COPLEY TOWNSHIP  
 MAJOR SITE PLAN/VARIANCE  
 1321 CENTERVIEW CIRCLE  
 MEDVET AKRON  
 STAFF REPORT

March 7, 2022

PROJECT: Med Vet-Building Addition and Parking Expansion  1321 Centerview Circle/3675 Copley Road  PPN: 1508153/1502424	APPLICATION TYPE: Major Site Plan; Variance Application
APPLICANT/LANDOWNER	APPLICANT: Cody Free, Korda  ON BEHALF OF: MedVet  LANDOWNERS: Broadstone MV Portfolio LLC/Copley Road Holdings LLC
COMPANY PERFORMING WORK REQUESTED	Korda
INVESTMENT	\$300,000
APPLICATION SUMMARY	Applicant, Cody Free-Korda, on behalf of MedVet Akron, is requesting approval to construct an addition and parking expansion.
INITIATED BY	Applicant
DECISION TYPE	<input type="checkbox"/> Informational <input type="checkbox"/> Direction <input checked="" type="checkbox"/> Action
CODE REFERENCES	<p>Article 5, Section 5.01 I-Industrial, D. Development Standards</p> <p><b>D. Development Standards</b></p> <ol style="list-style-type: none"> <li>1. Minimum Front Yard Setback From the Street Right-of-Way Line – Twenty-five (25) feet except as otherwise required in this Article.</li> <li>2. Minimum Rear Yard Setback – Twenty-five (25) feet except as otherwise required in this Article.</li

#### 14.08 Screening and Landscaping of Parking Lots

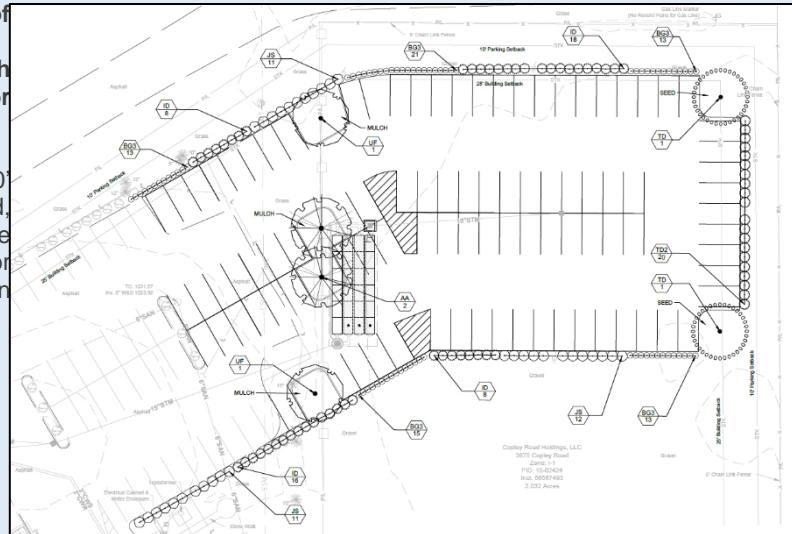
Recommend adding a small interior island in center parking.

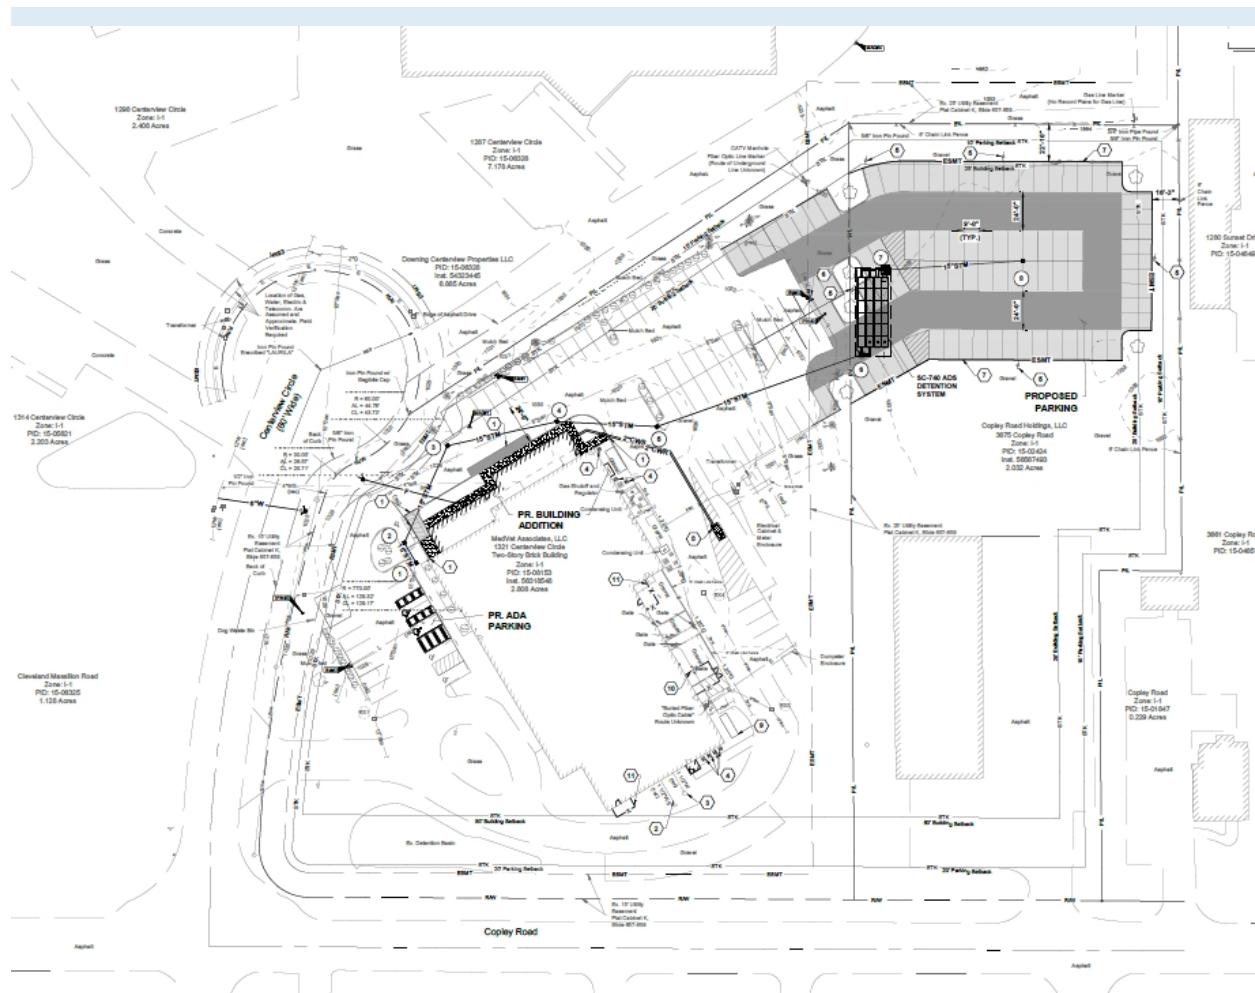
Parking calculations provided for a similar MedVet Site located in Cleveland Ohio.

Copley MedVet: 31,000 square feet (155 spaces requested)  
Cleveland MedVet: 35,000 square feet (175 spaces)
